**Proposed Rezoning From “AGR” & “GB” To “G/IC” for
a Proposed “Social Welfare Facilities” (Residential Care Homes for The Elderly) (RCHE)
Lot 232 RP, 232 S.A RP, 232 S.A ss. 1 to 14, 232 S.B RP, 232 S.B ss. 1 to 27,
232 S.C to 232 S.E, 233 RP, 233 S.A to 233 S.M, 237 RP, 237 S.A to 237 S.R,
239 RP, 239 S.A to 239 S.G in D.D.23, Tung Tsz, Tai Po, N.T.
S12A Application for Planning Application No. Y/NE-TK/19
Response-to-Comment – SWD
(Updated 21 February 2025)**

LG/F PLAN
ENTRANCE & CARPARK

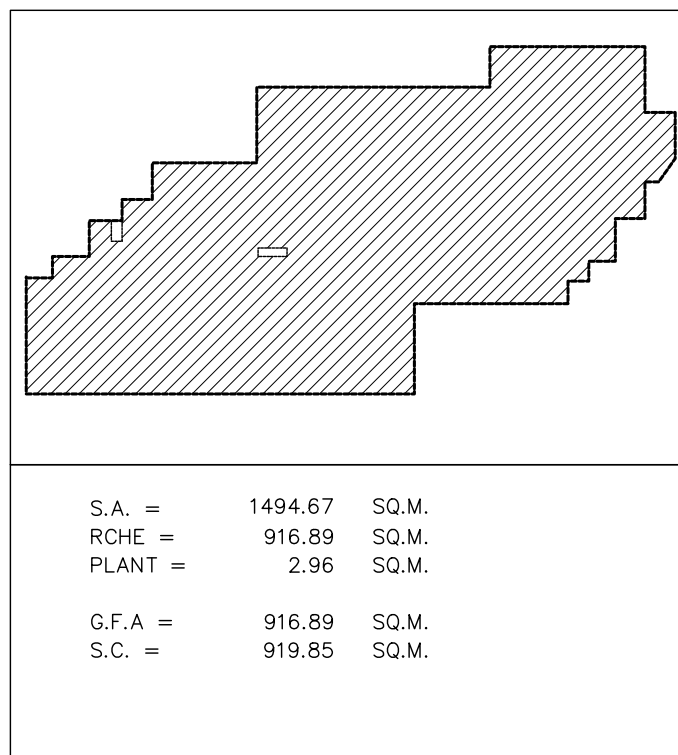
Comments	Response
<p>According to para. 4.4.1 of the CoP, the clear width of every passage and doorway shall not be less than 1 050 mm and 800 mm respectively, so as to facilitate residents using wheelchairs or walking aids to enter or pass through any rooms, including bedrooms and toilets/bathrooms, without assistance and unnecessary difficulty. Would the applicant please review the size and layout design of the two-bed suites.</p> <p>8. All facilities (such as CAFE and GYM on LG/F, SALON and MEDICAL CLINIC on UG/F) of the RCHE should be solely used by residents of the RCHE and should not be opened to other parties or public use. The applicant is advised to confirm such arrangement.</p> <p>9. Staff quarters on 8/F is not a provision for RCHE and should not be included in the proposed RCHE.</p> <p>10. Please clarify whether the canteen and work stations on 8/F are for the staff use. Staff canteen is not a provision for RCHE.</p> <p>11. Please name all the boundary/extent on the upper left corner of the layout plans.</p> <p>12. The kitchen is situated on 8/F. Please indicate/clarify if there is/are any dumb waiter for meal delivery to other floors and indicate alternative arrangement(s) if this facility is not provided.</p> <p>13. Please indicate the parking/loading/unloading area for emergency vehicles including</p>	<p>Confirmed. The arrangement RCHE should be solely used by residents of the RCHE and should not be opened to other parties or public use.</p> <p>Noted.</p> <p>8/F is for staff use. Canteen is for convenience of the staff.</p> <p>Dumb waiter provided. Refer to G-07.</p> <p>Revised. Please refer to G-02. The loading/unloading is for both mini-bus and emergency</p>

6/F PLAN
RCHE

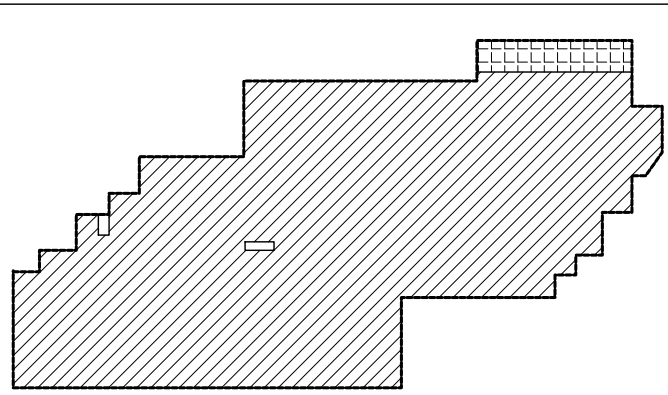
Comments	Response
<p>3. Regarding the flat roof on 7/F and roof garden on R/F, the applicant should follow para.16.2.4 of the CoP which states that "Residents of RCHE should be provided with a safe and protected living environment; effective measures shall be implemented and notices be posted to prevent residents from colliding with large floor-to-ceiling glass and entering prohibited areas such as the server room, rooftop or balcony". To address the safety concern, please provide more safety measures in addition to the basic requirement of a 1100 mm parapet wall and ensure that precautions to be taken for the open sitting areas.</p> <p>4. According to Section 21(c) of Residential Care Homes (Elderly Persons) Regulation, Cap. 459A, the ceiling of every room shall, unless otherwise permitted by the DSW, be situated at a height of not less than 2.5 m measuring vertically from the floor or not less than 2.3 m measuring vertically from the floor to the underside of any beam.</p> <p>5. Barrier free access for the disabled has to be provided in the RCHE premises.</p> <p>6. The applicant should ensure that the RCHE shall be accessible by emergency services.</p> <p>7. It is noted that two beds inside the 2-bed suites are placed adjacent to each other without any passage between the beds. According to Section 21(a) of Residential Care Homes (Elderly Persons) Regulations, Cap. 459A, every passage and doorway shall be wide enough to accommodate residents using walking aids or wheelchairs.</p>	<p>Noted. All parapets are 1.1m above finish floor level.</p> <p>Noted. Would be complied in detail design.</p> <p>Complied.</p> <p>The RCHE is accessible by emergency services like Ambulance.</p> <p>Revised. Refer to G-05, G-06.</p>

Comments	Response
<p>ambulances.</p> <p>14. The basic facilities in the RCHE shall include dining/sitting area. Please indicate on the layout plan if this is provided.</p> <p>15. According to para. 6.2 of the CoP, please ensure that the minimum area of floor space for each resident should be 9.5 sq m..</p> <p>16. Please confirm that all habitation area of the RCHE should be provided with openable/prescribed window(s). Furthermore, no part of the area used for habitation shall be more than 9 m, measured within the habitation area from the prescribed window(s).</p> <p>17. Please clarify if there is any rehabilitation area and indicate alternative arrangement(s) if this facility is not provided.</p> <p>18. Please provide a more detailed layout of the attached toilets cum bathrooms/shower rooms inside the dormitories and suites.</p> <p>Whether Premium Concession Scheme is applicable to the proposed RCHE</p> <ul style="list-style-type: none"> The proposed RCHE should comply with all the requirements of the Incentive Scheme to Encourage Provision of Residential Care Home for the Elderly Premises in New Private Developments (the Incentive Scheme) as set out in Lands Department (LandsD)'s Practice Note Issue No. 5/2023. 	<p>vehicles.</p> <p>Revised. Please refer to G-04 to G-06.</p> <p>Confirmed.</p> <p>Confirmed.</p> <p>Tai Chi square and outdoor – exercise equipments in roof garden would be provided for rehabilitation.</p> <p>Revised. Please refer to G-04 to G-06.</p> <p>Noted.</p>
